Title	Size	Number	Revision
Date: 6/30/2023	C	Sheet of 1	
File: C:/Users/.../igc_cena_host_board.nel			Specified By:

C:\Users...\vccs_pullup.SchDoc

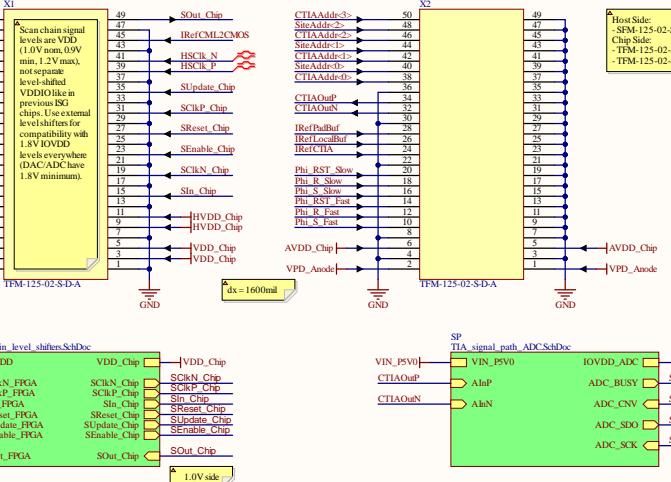
Use DACs to set voltages and bias currents.
Do not use any pots on this board.
DAC1_VDD, HVDD, AVDD, VPD
DAC2_IRefPadBuf, IRefLocalBuf, IRefCTIA, IRefCML2CMOS

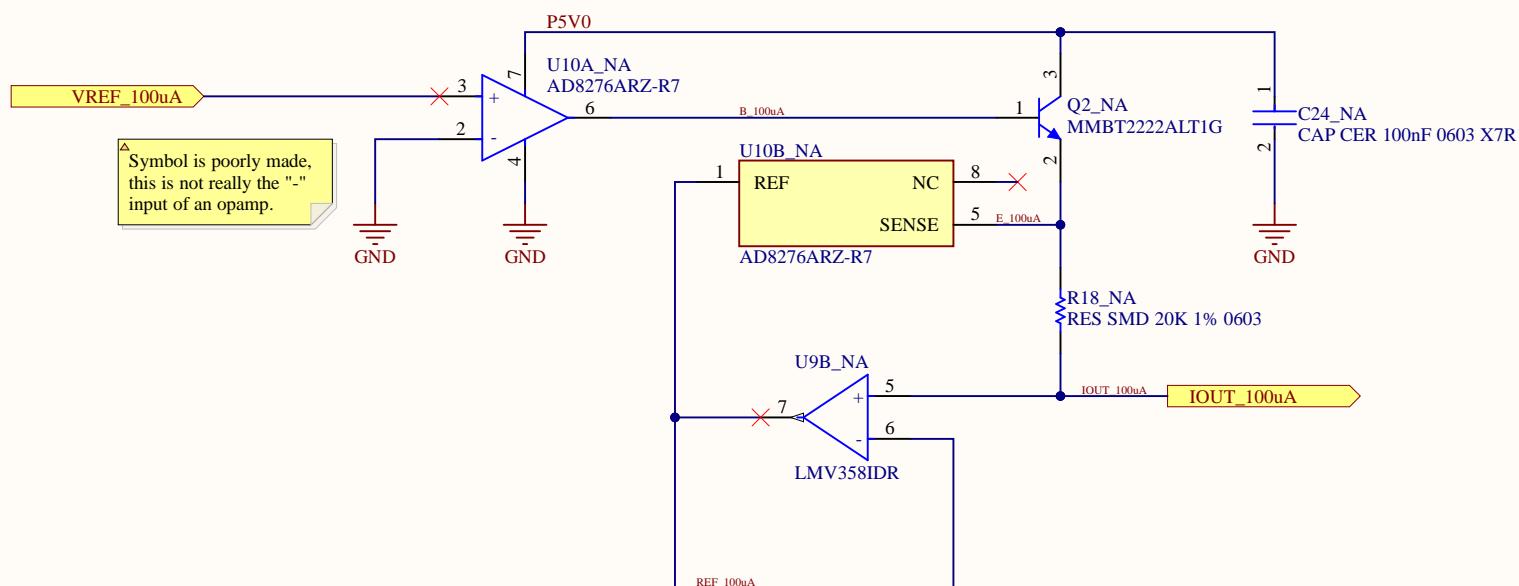
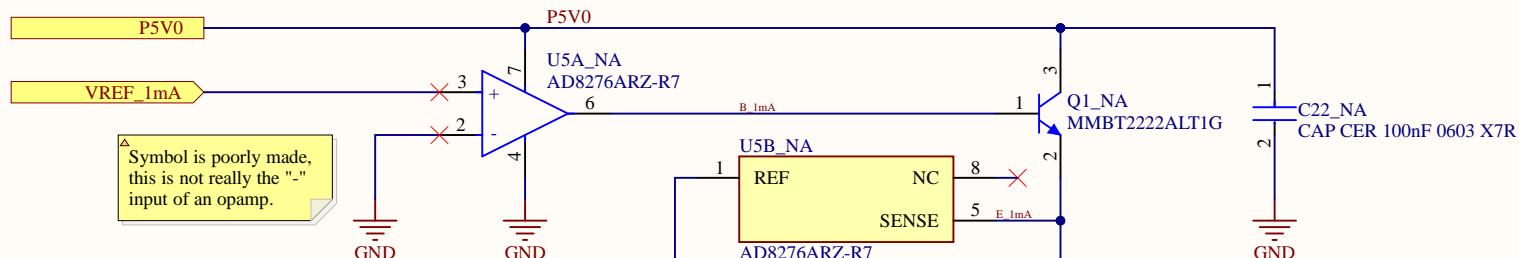
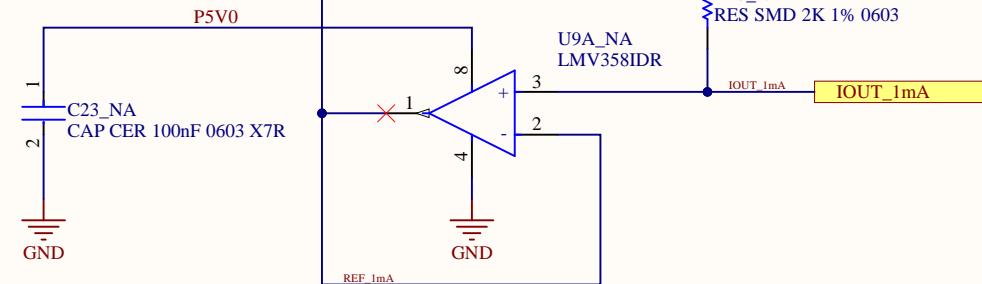
INA597 is a similar pin-compatible replacement from TI that is in stock, use it instead.

C:\Users...\vccs_pullup.SchDoc

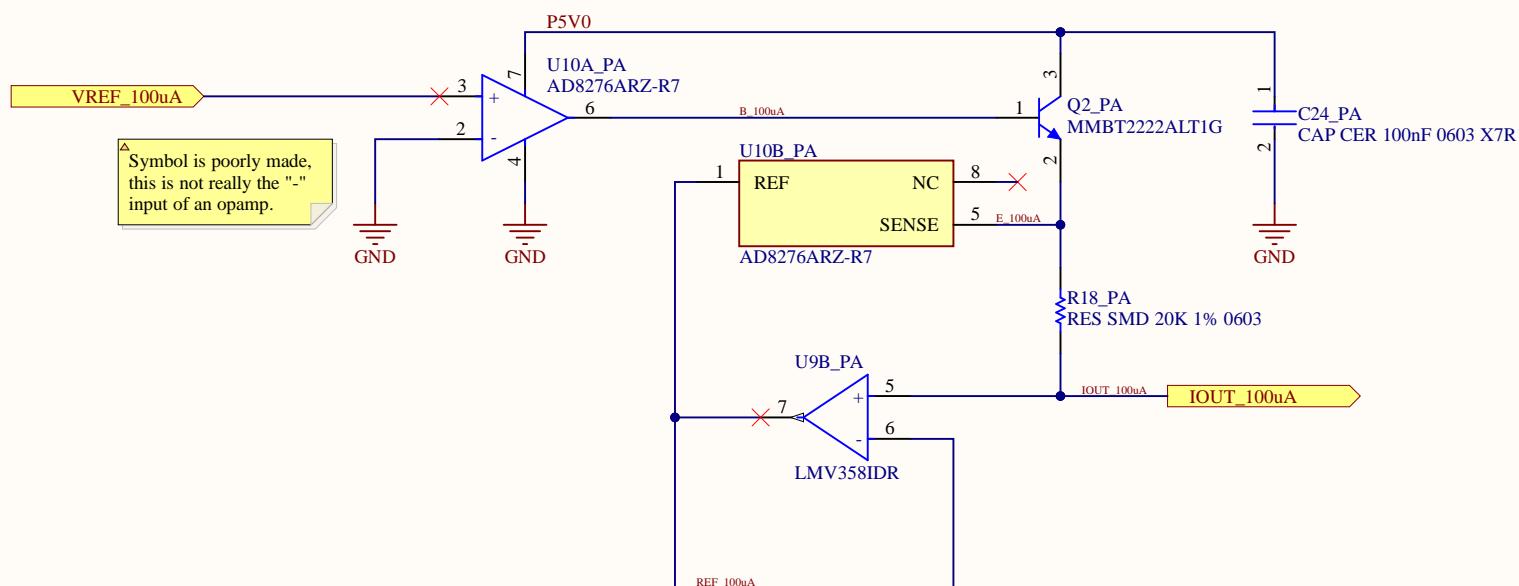
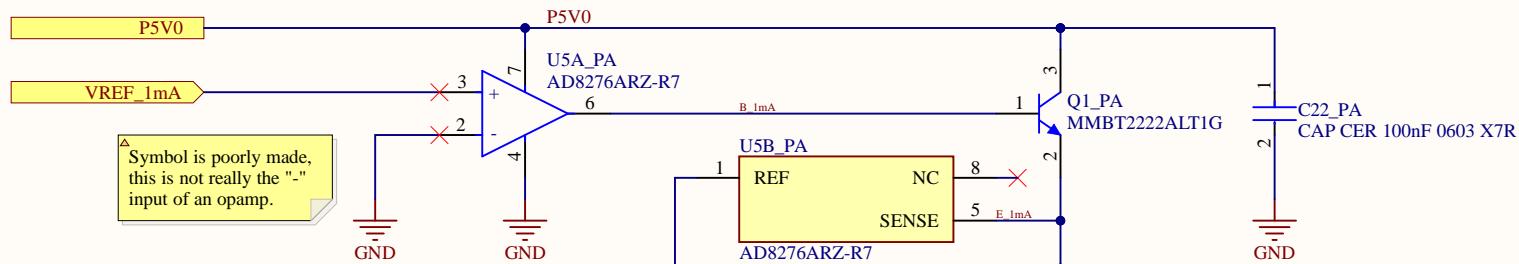
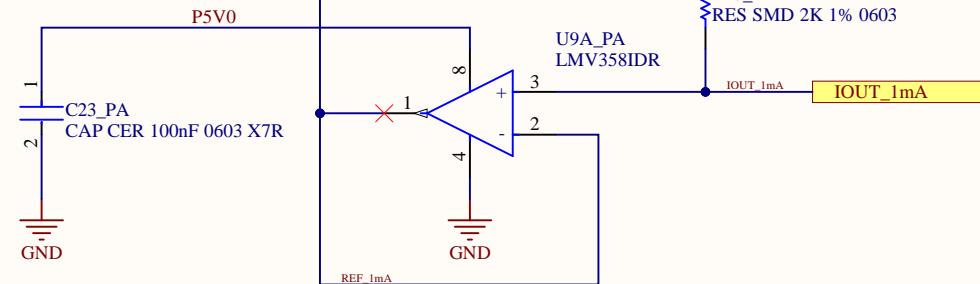
INA597 is a similar pin-compatible replacement from TI that is in stock, use it instead.

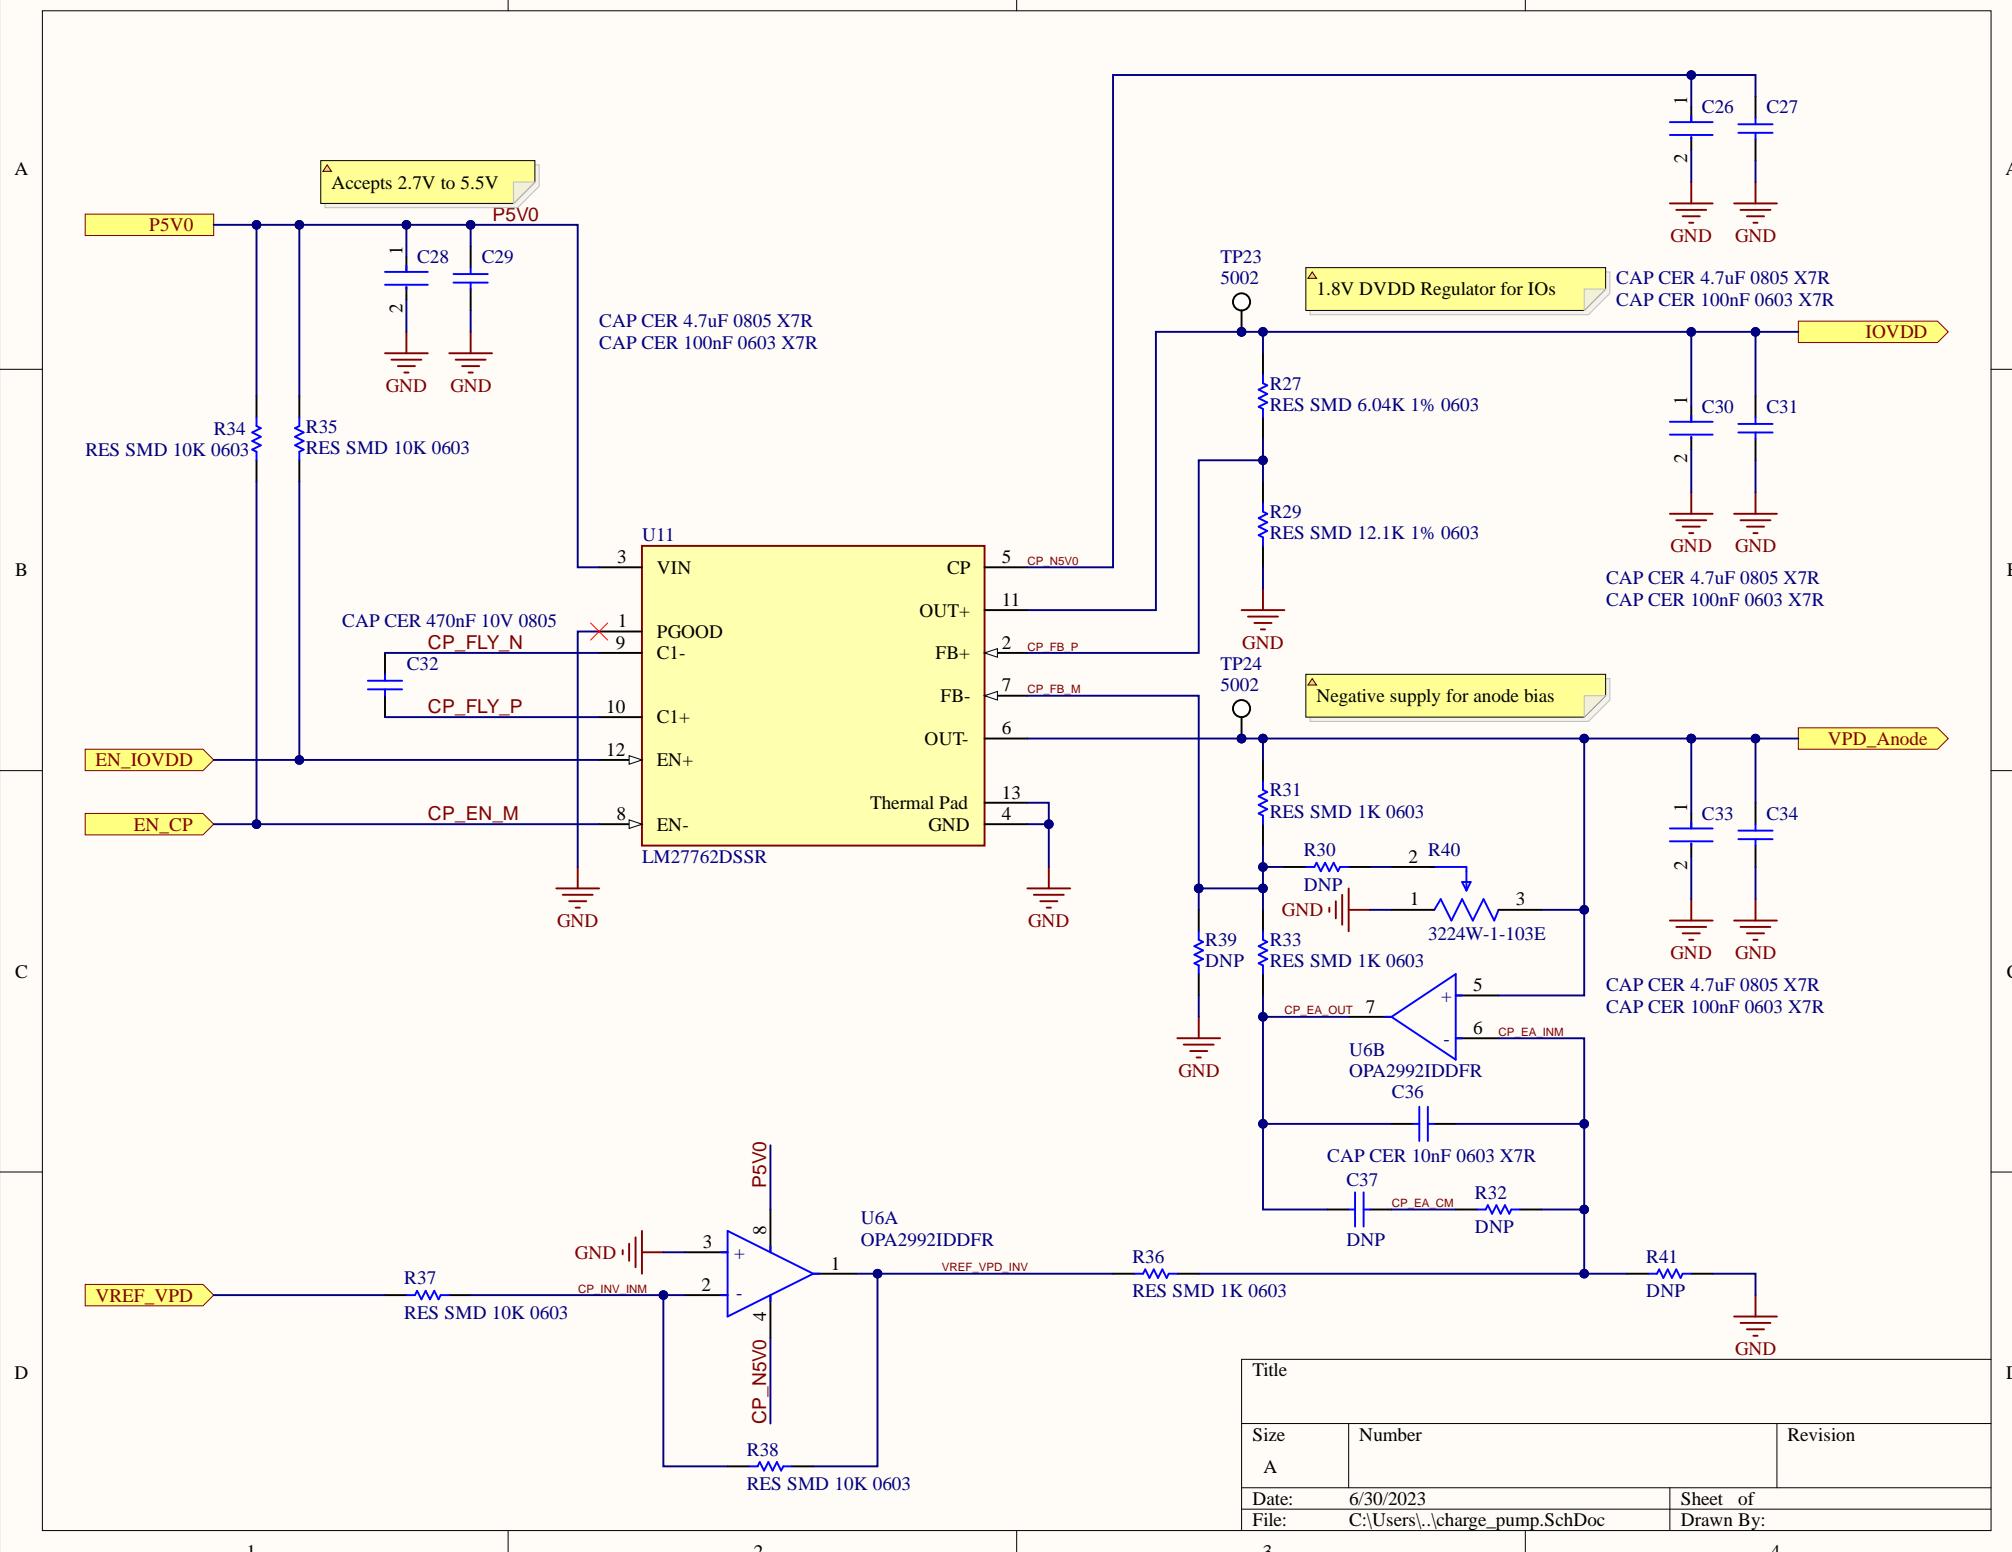
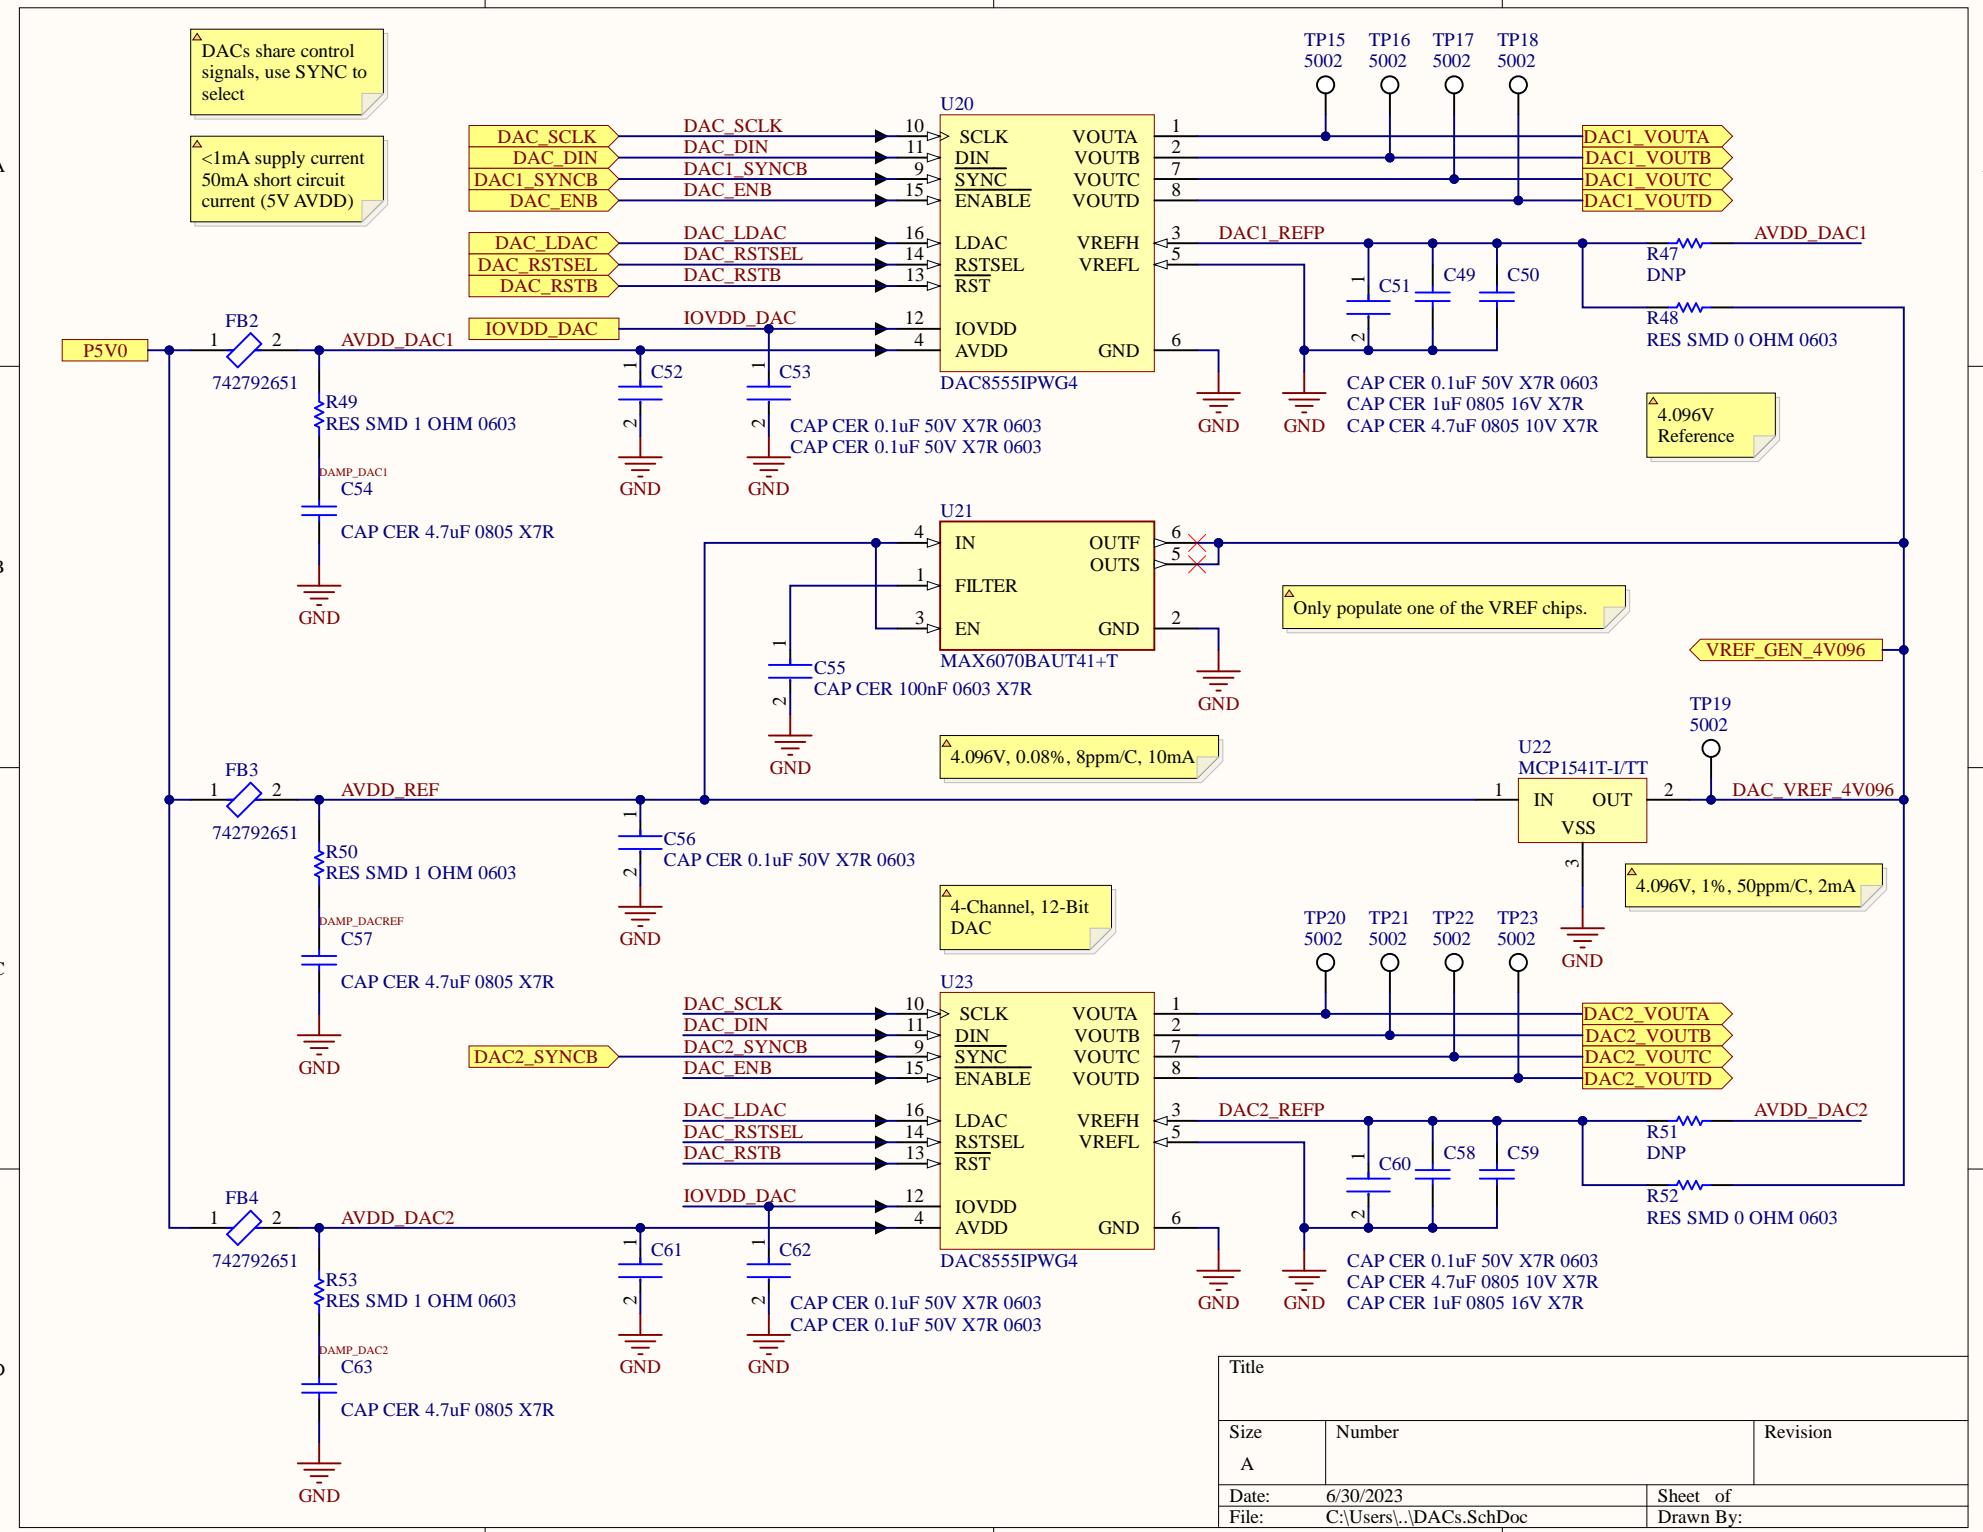
todo: decaps (do we really need 1 per?)
